Staff Report: Site Plan 820090020, Pike Center

DESCRIPTION: Addition of two pad-site commercial retail buildings, a 3,710-square foot bank with three drive-through lanes and a 6,000-square foot retail building, totaling 9,710 gross square feet to an existing retail center site, for a grand total of 81,007 gross square feet, on 6.84 acres of C-4-zoned land; in the northeast quadrant of the intersection of Rockville Pike and Bou Avenue; North Bethesda/Garrett Park Master Plan. The application includes a request for two waivers from the parking requirements.

APPLICANT: JBG/Pike Center, LLC

Chapman Avenue Bikeway Detail

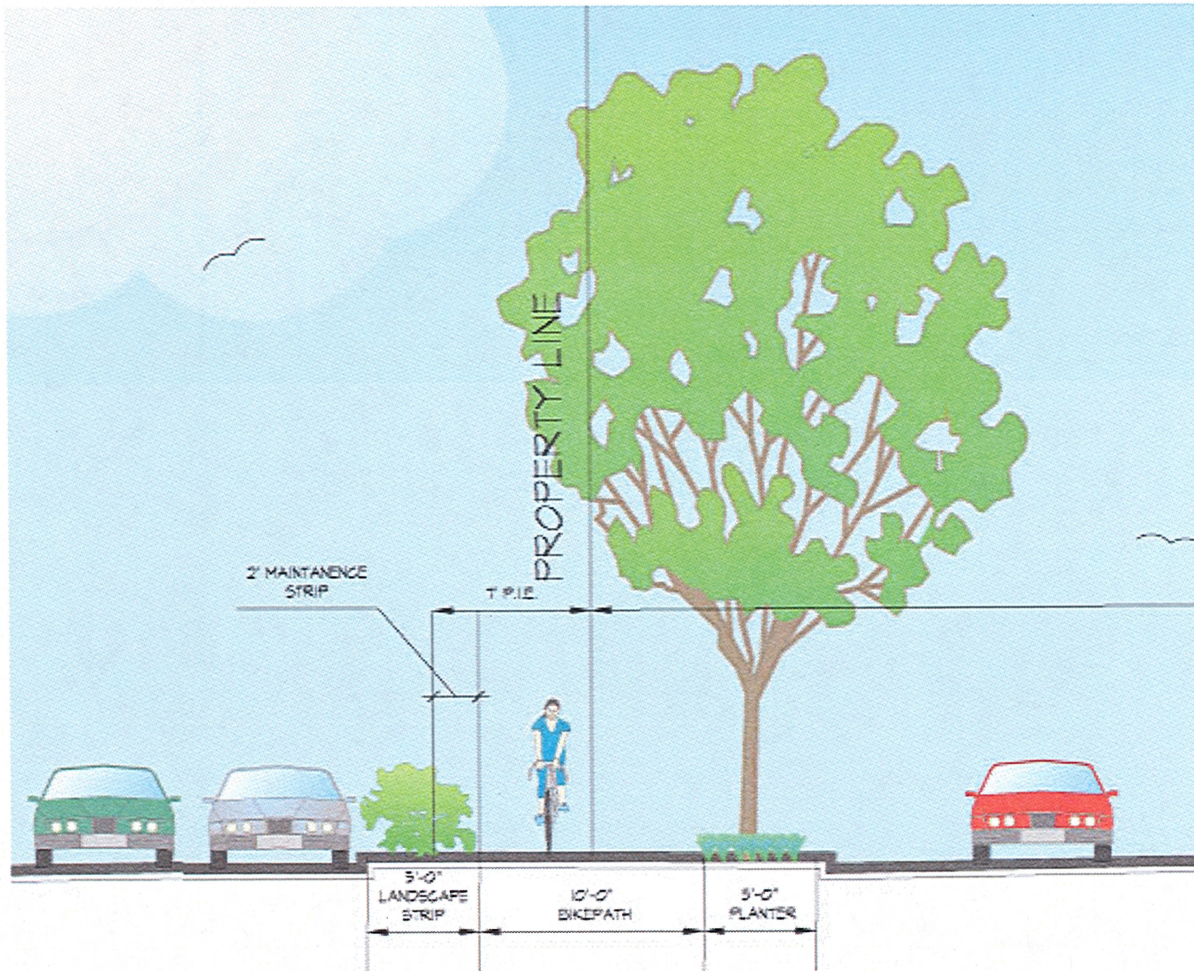
The second request deals with the required 10-foot landscape strip adjacent to street rights-of-way (59-E-2.71). Given the need to accommodate a Master-Planned shared-use bike path along Bou and Chapman Avenues, there is insufficient room in the existing street configurations for the full complement of 10 feet. The Applicant is proposing to reduce each of the landscape strips to 5 feet in width. The public benefit derived from the extension of the bike paths outweighs the loss of vegetative buffer between parking and street. Staff supports the requested waiver.
